REVISED FEASIBILITY STUDY

CLEANUP AND ABATEMENT ORDER NO. R9-2017-0021

Harbor Island – East Basin Sediment Assessment/Cleanup Site

APPENDIX A: RESPONSE TO WATER BOARD COMMENTS

Figure 1
Site Plan
 Former Tow Basin and Former Marine Terminal and Railway Facilities

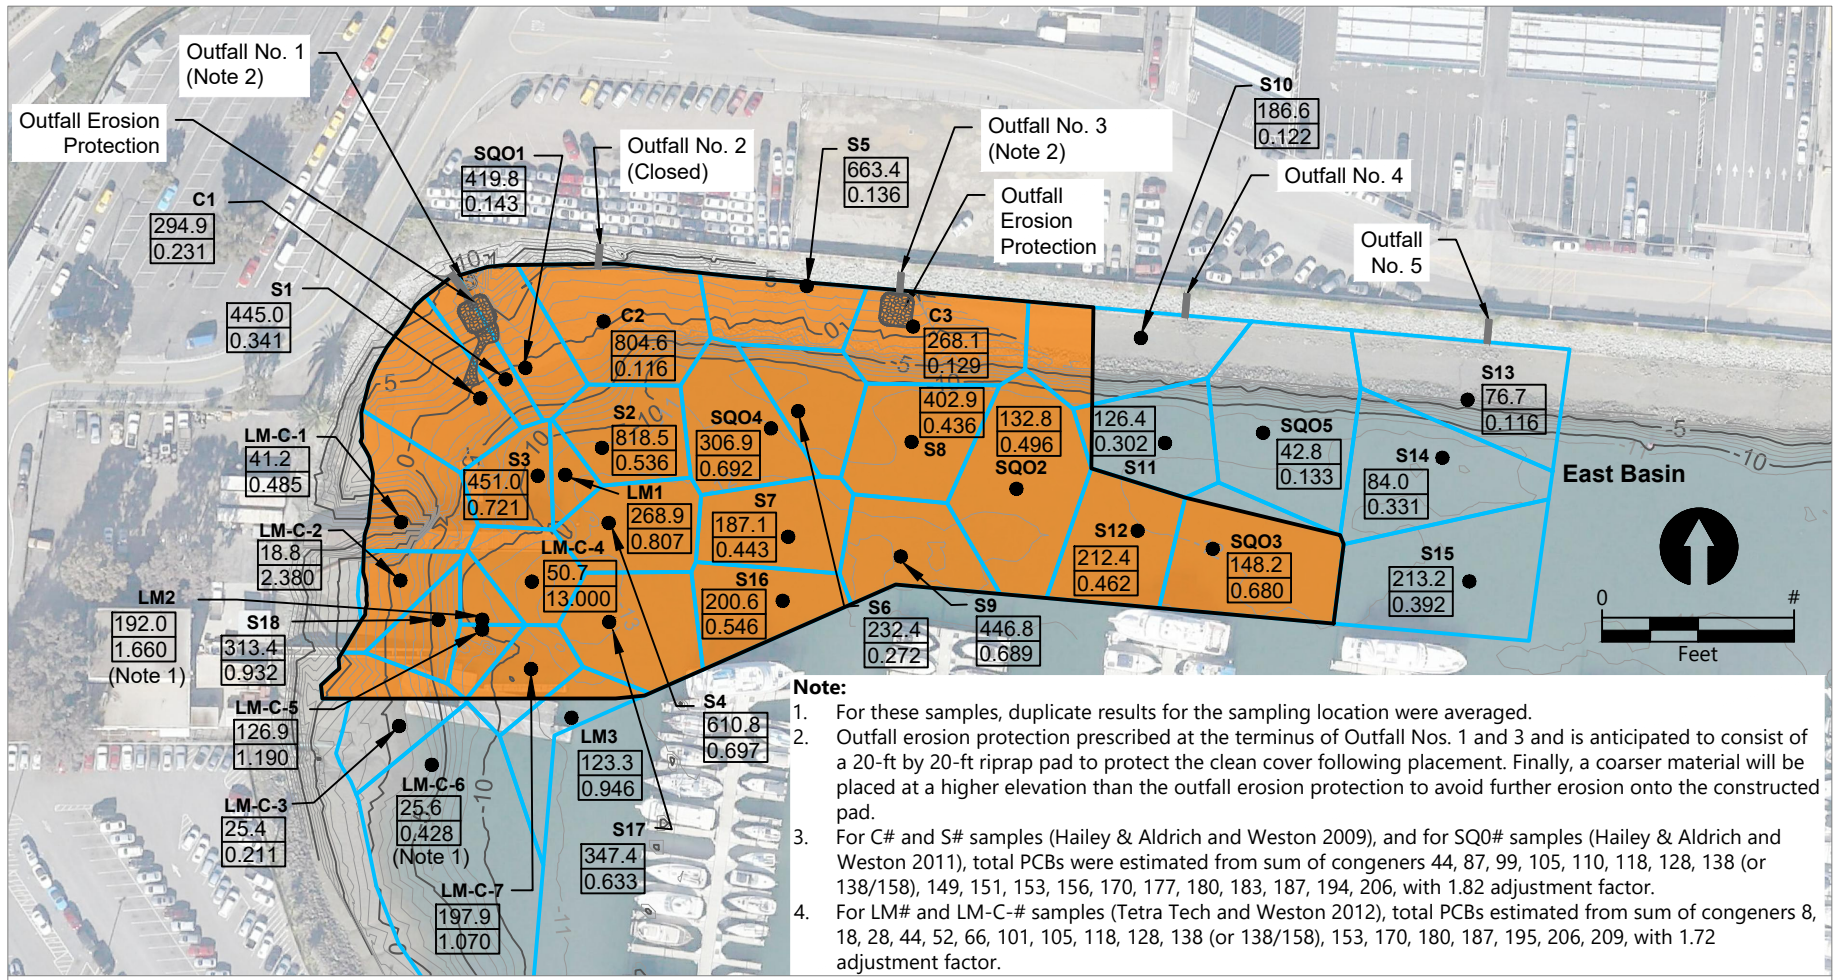
Response to Comment 16: The Regional Board requested an explanation on the rationale for placement of the remedial footprint boundaries as shown on Figures 1 through 4.

3. The Study states, “Prior to the CAO (Water Board 2017), sediments targeted for remediation at the site were identified in part through the State of California’s SQO process and bracket the 36 impacted locations shown in Figure 1.” Please explain what is meant by “bracket.”

Response to Comment 15: The Regional Board requested that the figures be revised to match the original polygon boundaries. Lockheed Martin responds that the polygons presented in Figures 1 through 5 of the Feasibility Study will be revised to match those presented in Appendix A (and utilized for the SWAC analysis).

Figure 4
Remedial Alternative 4: Combination
 Former Tow Basin and Former Marine Terminal and Railway Facilities

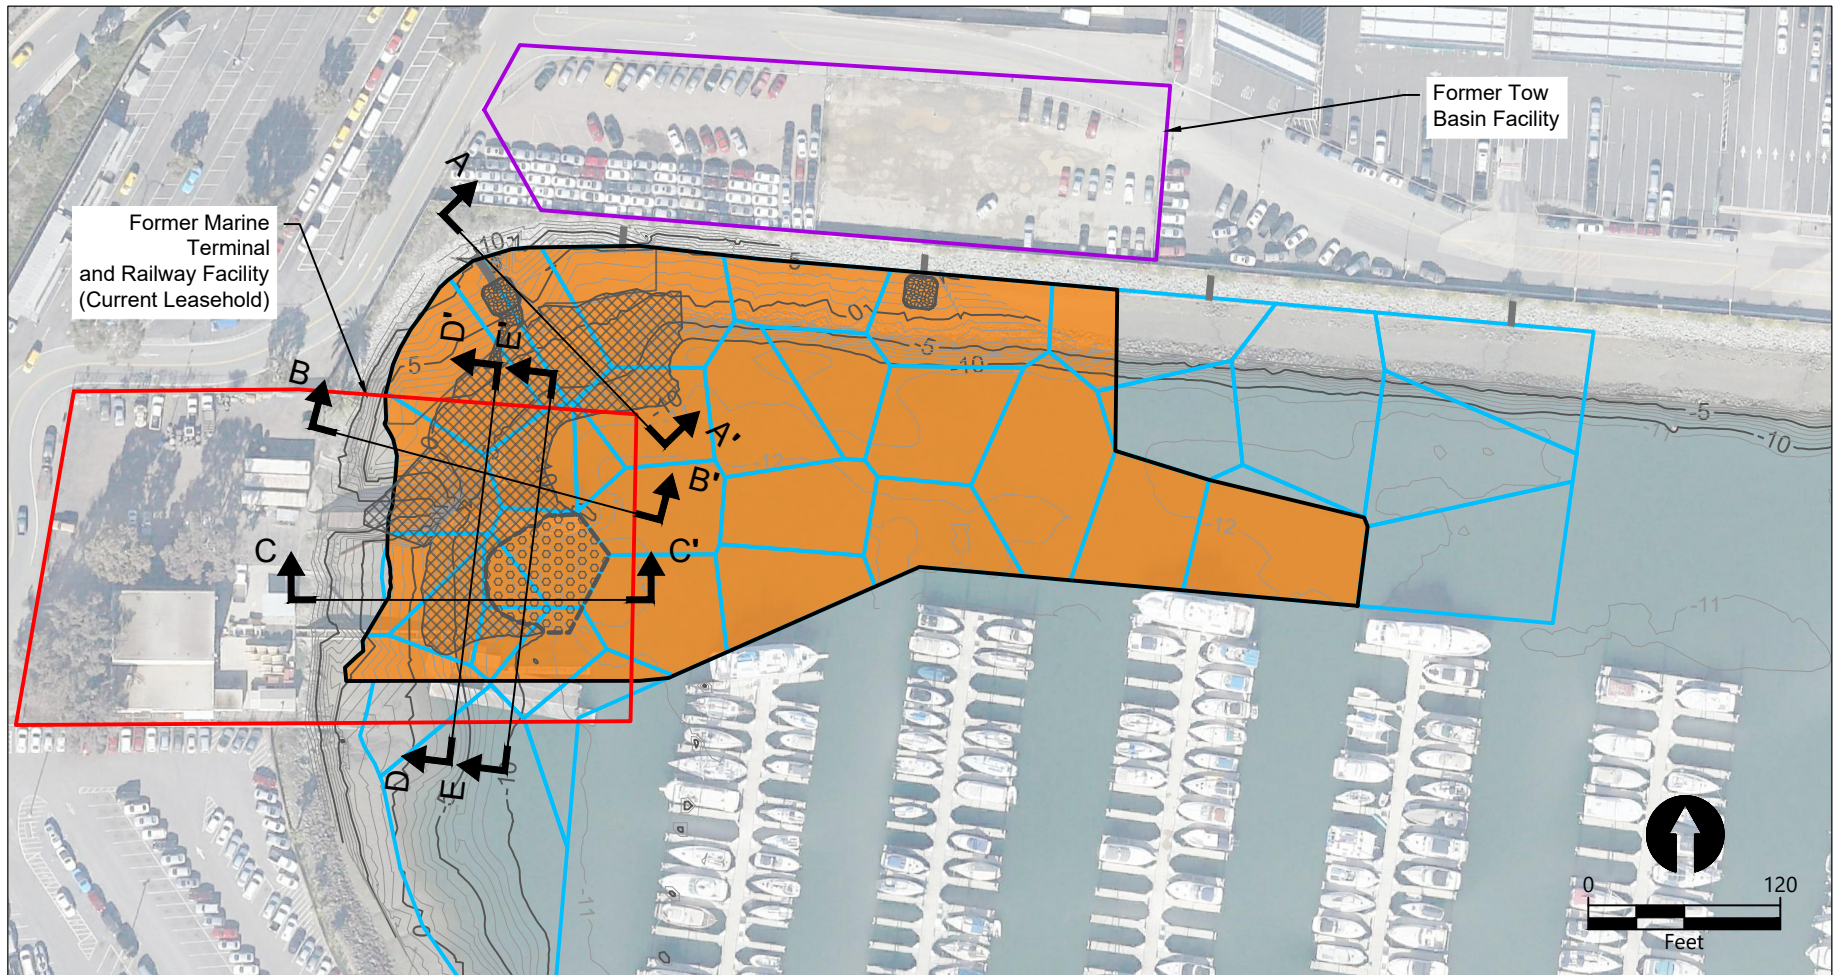
Response to Comment 27: The Regional Board requested additional explanation for various remedial activities shown on Figure 4 and as described in Remedial Alternative 4.

ID No.	Reviewer	Comment Date	Section Name/Topic	Comment Text	Response Text
27	Water Board	10/27/2017	Section 5.3.4: Remedial Alternative 4: Combination	The various remedial activities shown on Figure 4 and described in this section for Remedial Alternative 4 require additional explanation:	Alternative 4 relies on application of the clean sand cover to achieve the CAO specified cleanup levels on a SWAC basis. In addition to clean sand cover placement, sediment removal by mechanical dredging has been included for areas with elevated chemical concentrations (i.e., the elevated mercury levels detected at LM-C-4) and in areas where navigational depth requirements prevent placement of the clean sand cover. Placement of clean sand augmented with activated carbon has been included in the northwest corner of the East Basin to address some concerns presented by other responsible parties during the settlement negotiations. Other elements of Alternative 4 include construction of a splash pad to prevent erosion of the clean sand cover adjacent to Outfall Nos 1 and 3 and long-term monitoring. It should be noted that placement of the clean sand cover alone is sufficient to achieve the CAO specified cleanup levels on a SWAC basis and other elements have added to increase the long-term effectiveness and permanence and implementability of the alternative (including other responsible party's concerns). See Comment 19 regarding the application of GAC in the northwest corner.

29	Water Board	10/27/2017	Section 6.1: Overall Protection of Human Health and the Environment	The remedial plan shown on Figure 4 is inconsistent with the objective of the cleanup and abatement efforts as outlined in Section 1. LM-C-1 (total PCBs 41.2 µg/kg; mercury 0.485 mg/kg) and LM-C-3 (total PCBs 25.4 µg/kg; mercury 0.211 mg/kg), both of which have COC concentrations below background levels, are within the dredge footprint whereas LM1, LM2, LM3, LM-C-2, LM-C-4, and LM-C-7, all of which have at least one of the COCs above background levels, are outside of the dredge footprint. Section 5.1 states, "Sediment removal by mechanical dredging is appropriate for areas with elevated chemical concentrations or areas where navigational depths should be retained or to remove high-concentration material." Further, the analysis in Section 6.1 states, "Dredging would occur in a discrete area that would remove sediments with elevated COC concentrations greater than the CAO cleanup level." Arguably only LM-C-2 and LM-C-5, which exceed mercury background levels, and SQ01 and LM-C-5, which exceed total PCBs background levels, are in the dredge footprint and would be consistent with this statement. Few polygons with "elevated COC concentrations greater than the CAO cleanup level" are in fact within the dredge footprint. The rationale for the remedial plan as shown on Figure 4 is therefore unclear. Has dredging been proposed for navigational needs or to address COC concentrations exceeding background-based cleanup levels? See also comments regarding the validity of perceived environmental benefit as stated under comment no. 23.	See response to Comments 16 and 27. For clarification, the text in Section 5.1 and 6.1 of the FS does not state that that dredging will occur in all areas with elevated COC concentrations greater than the CAO cleanup level, as that is not necessary to achieve background concentrations on a SWAC basis. The recommended remedial alternative presented in the FS is predicated to meet the SWAC for the entire Site and includes removal to address elevated mercury concentrations and to meet navigation requirements.

The dredge prism was initially designed to meet the Port District’s navigation requirements (note that sand cover attains the post remedial SWAC and the CAO cleanup objectives) and further modified to address the higher mercury concentrations. The dredge areas also considered a final configuration that would not impact the stability of the existing revetment. Specifically, side slopes were necessary landward of the dredge prism to allow for dredging to -11 feet MLLW (inclusive of one foot over-dredge). These side slopes are detailed on the cross-sections presented on Figures 6a through 6c. All dredge areas and slide slopes will receive sand cover.

Figure 1 - Remedial Alternative 4: Sampling Stations at Outfall No. 1

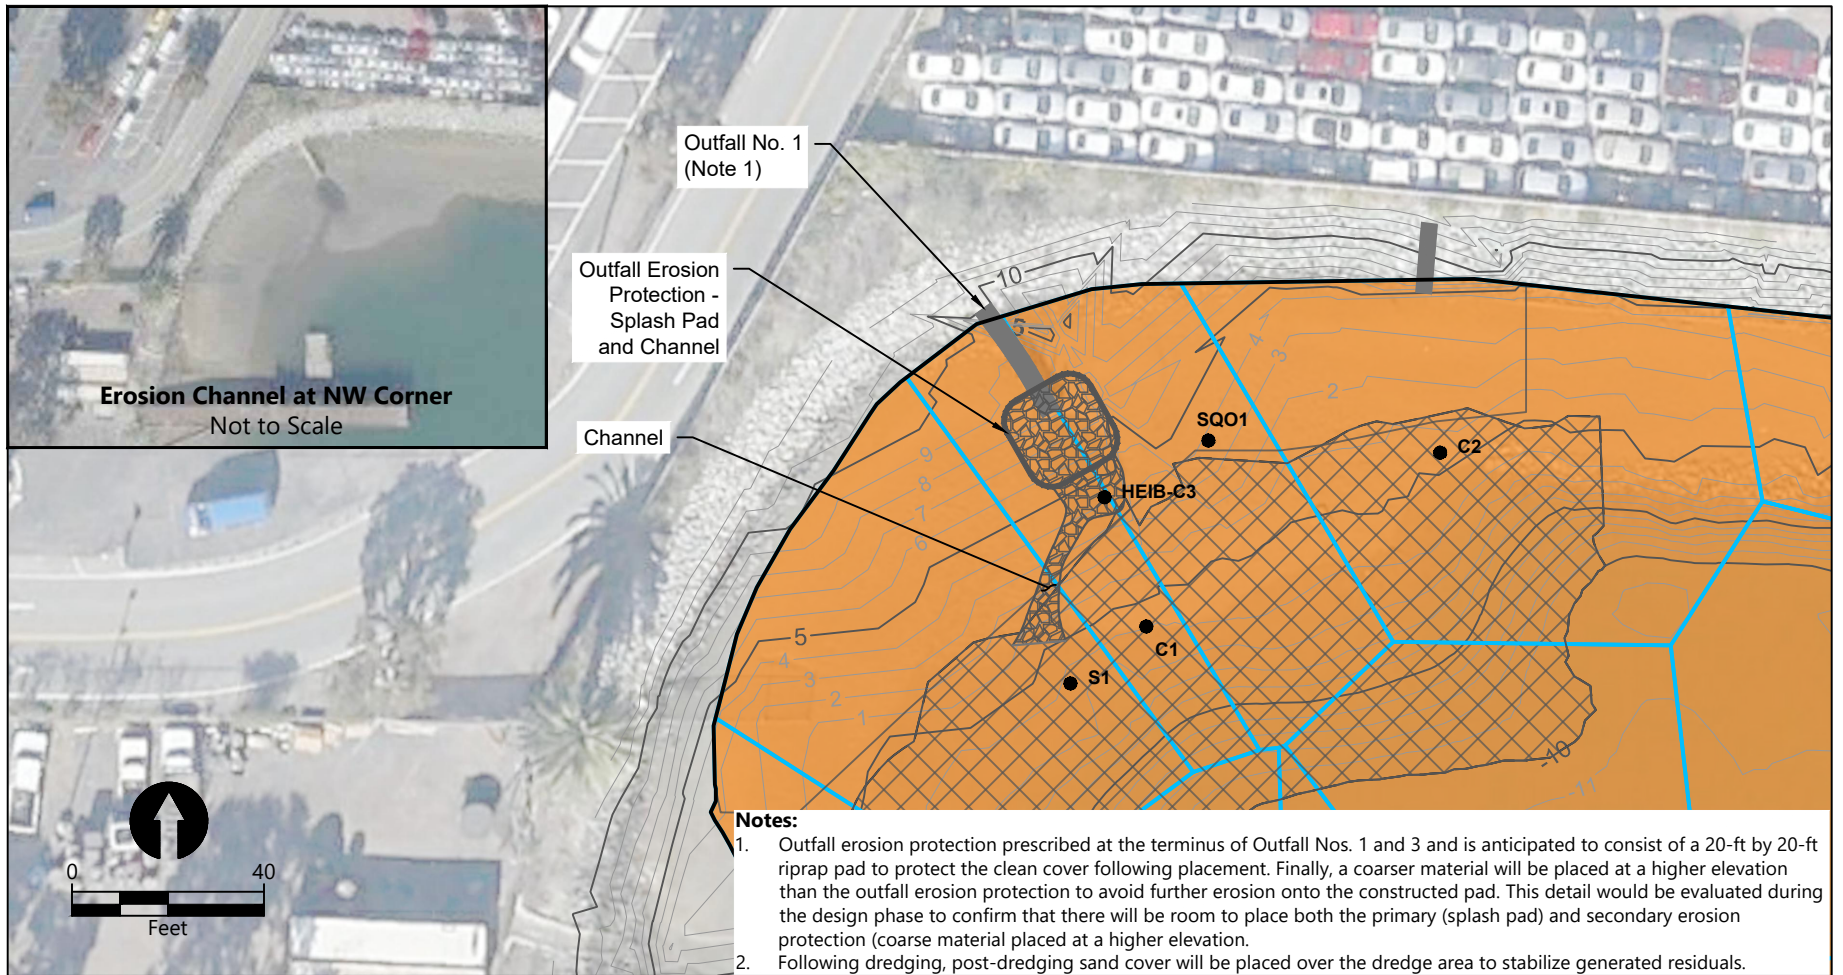
14. *Figure 1.* The map shows 11 locations for porewater sampling. Table 3 indicates that 12 locations will be subjected to porewater sampling. Revise the map to include all 12 porewater sampling locations.

We propose to move SQ01 further upslope to be more representative of the intertidal area (Figure 1). The Final FS will include SQ01 as part of a revised predicted post-remedial SWAC and the sample location modification will be noted in the Plan results. The 36 surface sediment samples will be submitted for total PCBs (congeners), total mercury, total solids, total organic carbon, and grain size.

13	Appendix E	<p><i>Table 2.</i> Table 2 lists the post-remedial monitoring activities. There is a column for pre-remediation sampling and footnote 1 also indicates monitoring activities that will have a pre-remedial component. Provide a revised version of Table 2 that simplifies the proposed sampling scheme for clarity.</p>	Table 2 will be revised to increase clarity.
14	Appendix E	<p><i>Figure 1.</i> The map shows 11 locations for porewater sampling. Table 3 indicates that 12 locations will be subjected to porewater sampling. Revise the map to include all 12 porewater sampling locations.</p>	Figure 1 will be corrected.
